Access Compliance Report Public Rights-of-Way (Curb Ramps)

Main Street: BENJAMIN_DR Cross Street: CHANTILLY_LN Location: E

ADA ID: RPRK211020155347 Ramp Type: Type 4 - Parallel Initial Pass/Fail: Fail Overall Compliance: No Severity Score: 30

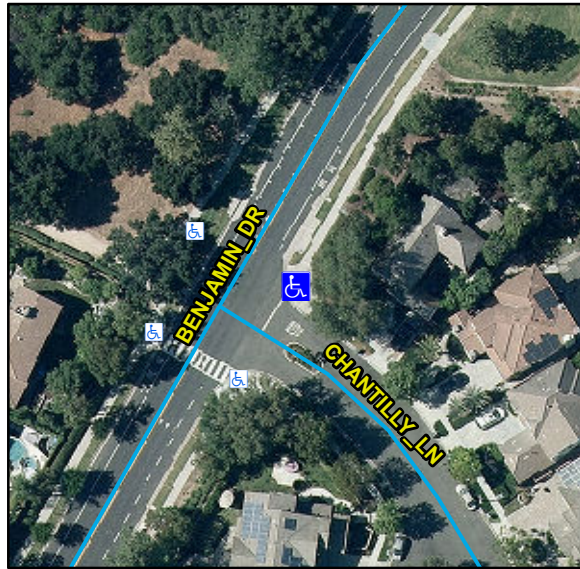
Compliance	Description	Data	Compliance	Description	Data
N/A	Ramp Length LT (in)	88	N/A	Ramp Length RT (in)	87
Yes	Ramp Width LT (in)	126	Yes	Ramp Width RT (in)	126
Yes	Ramp Run Slope LT (%)	7.5	Yes	Ramp Run Slope RT (%)	0.3
No	Ramp Cross Slope LT (%)	9.7	No	Ramp Cross Slope RT (%)	8.2
N/A	Landing Present	N/A	N/A	DWS Provided	N/A
N/A	Landing Length (in)	N/A	N/A	DWS Contrast	N/A
N/A	Landing Width (in)	N/A	N/A	DWS Length (in)	N/A
N/A	Landing Run Slope (%)	N/A	N/A	DWS Full Width	N/A
N/A	Landing Cross Slope (%)	N/A		DWS Offset Type	N/A
N/A	Landing Movement Obstructed?	N/A	N/A	DWS Offset Left (in)	N/A
	Landing Movement Type	N/A	N/A	DWS Offset Right (in)	N/A
N/A	Landing Shared	N/A			
N/A	Clear Space	Yes			
N/A	Clear Space To Crosswalk (in)	N/A			
N/A	Marked Crosswalk 1	No	N/A	Marked Crosswalk 2	No
	Crossing 1 Direction	NW		Crossing 2 Direction	SW
	Marked Crosswalk 1 Width (in)	N/A		Marked Crosswalk 2 Width (in)	N/A

Remove & Replace Curb Ramp With Two New Directional Ramps or Equivalent.
